MINERALS PROGRAM INSPECTION REPORT

MINE NAME: AFS - Bennett Pit	MINE/PROSPECTING ID#: M-2001-038	MINERAL: Sand & borrow material	COUNTY: Adams
INSPECTION TYPE: Monitoring	WEATHER: Clear	INSP. DATE: May 21, 2024	INSP. TIME: 13:00
OPERATOR: Albert Frei & Sons Inc.	OPERATOR REPRESENTATIVE: Joel Boldoc and Martina Gilbert	TYPE OF OPERATION: 112c - Construction Regular Operation	
REASON FOR INSPECTION: Citizen Complaint	BOND CALCULATION TYPE: None	BOND AMOUNT: \$487,175.00	
DATE OF COMPLAINT: April 23	POST INSP. CONTACTS: None	JOINT INSP. AGENCY: County	
INSPECTOR(S): Nikie Gagnon	INSPECTOR'S SIGNATURE: 	SIGNATURE DATE: June 20, 2024

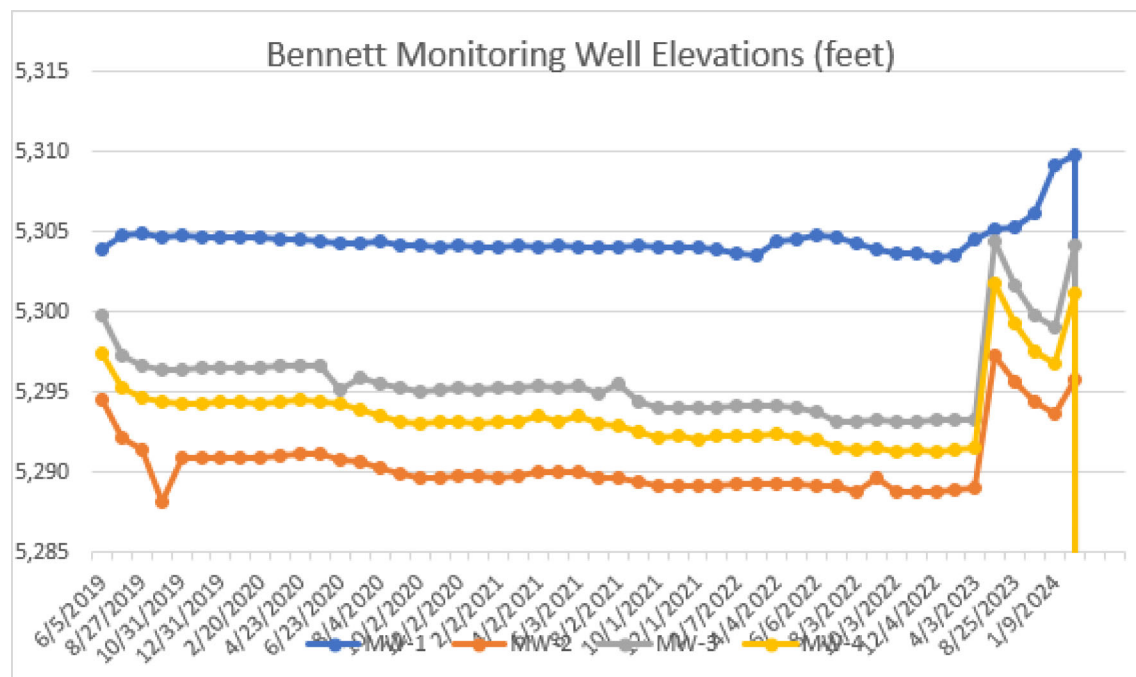
Below is the updated groundwater chart. MW-2, MW-3 and MW-4 are adjacent to the creek and MW-1 is further west (away) from the creek.

In the meantime, could someone please check the site and send me an update on the mining activities and how water is being managed? I know you are monitoring groundwater levels at the site, but this site is not approved for mining into and exposing groundwater.

We will get this addressed, I'll let you know how shortly.
